APPENDIX I.1

Comments on the Draft EIS and Responses

Southgate Project

Appendix I.3 - Southgate Project Response to Comments Side-by-Side Table

Figure I.5: Trends in Fossil Fuel Consumption by All Sectors (TBTU)

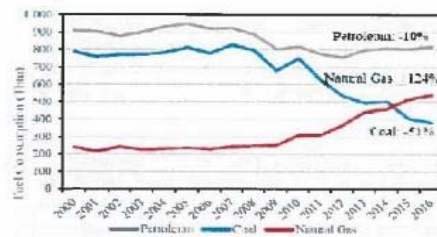
Recommendations: The EPA recognizes that this section of the DEIS needs to be further developed as the Commission receives agency and public input. While finalizing this discussion, the EPA has provided some general information regarding NC's demand/consumption regarding three energy sectors (See chart below). It is noted that in NC the natural gas sector has increased by more than 100%, but we also noted that the available volume of gas as of today is already exceeding NC's present consumption². We understand that one of the many issues FERC considers for its decision is market demand and supply. We recommend that the FEIS include a well-defined purpose and need that would address the underlining need for this project that balances the benefits and impacts from the proposal.

See response GEN-2 in appendix I.2.

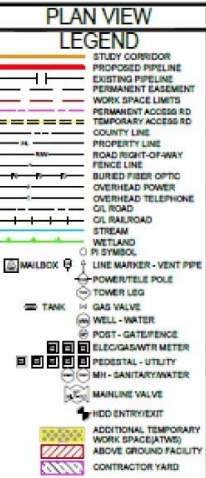
If one zooms in to about 300% on the alignment sheet on page four below, one may be able to make out the small print and thin lines identified in the legend.

The map shows the "EXISTING PIPELINE" (labeled "Williams Transco Pipeline") as a single broken black line with vertical bars located near the proposed "WORK SPACE LIMITS" indicated by a broken red line. The single broken black line with vertical bars, in fact, marks the SE boundary of the Williams Transco ROW, a 155' corridor containing four pipelines, a fiber optic cable, and an electric cable. The nearest Williams Transco Pipeline (D-Line) is 40' from the line shown on the map. Not all co-location properties have four Williams Transco pipelines (some have three) or a 155' ROW (many are undefined); nevertheless, the same error occurs on other alignment sheets: the single broken black line with vertical bars is far from the actual location of the closest Williams Transco gas line.

The red cloud-like outline along the bottom of the map appears to indicate an access road on the Williams Transco ROW and work area that were eliminated from the project on our property. We are grateful that Mountain Valley cancelled this part of its plan.
